DISCUSSION

G. H. Jirka¹

Kannberg and Davis address two important points in the design and analysis of multiple-port diffusers: (1) What is the mechanism of jet merging and how to model it? (2) What is the effect of jet merging on the mixing capacity of such diffusers?

Fig. 10 Stability of the flow field for multiport diffusers discharging into shallow water as a function of slot densimetric Froude number F_s , relative water depth H/B , and discharge angle, θ_0 . ($B = D^2\pi/4L$ is the equivalent slot width); after Jirka and Harleman [24]

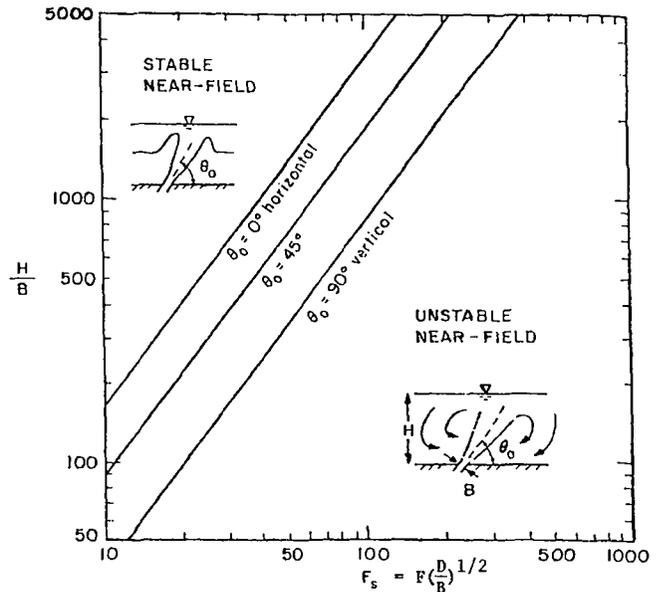
Finally, some caution has to be expressed regarding Kannberg and Davis' introductory claim that their analysis is applicable for the predictions of condenser heat discharges from electric power generation. In fact, the low buoyancy of such heated discharges in combi-

nation with the limiting water depth at usual disposal sites gives rise to dynamic instabilities in form of a recirculating eddy extending over the entire water depth. This discharge condition cannot be analysed by means of simple buoyant jet models as proposed by the authors. Stability criteria, which depend on relative water depth, discharge Froude number and angle, have been developed by Jirka and Harleman [4, 24] and are plotted in Fig. 10. Multiple-port diffuser designs for condenser heat discharge generally fall into the unstable discharge range. The practical application of the stable range, in which the authors' model is applicable, relates to sewage and blowdown diffusers, usually with higher buoyancy and lower flowrates.

We agree with Dr. Jirka that the present model should not be used in shallow stagnant receiving water where surface effects and instabilities are present. In flowing ambients, however, even at low velocities these effects are reduced and in some cases eliminated. In many cases the receiving water is sufficiently deep to use the model to predict the major portion of the plume's characteristics.
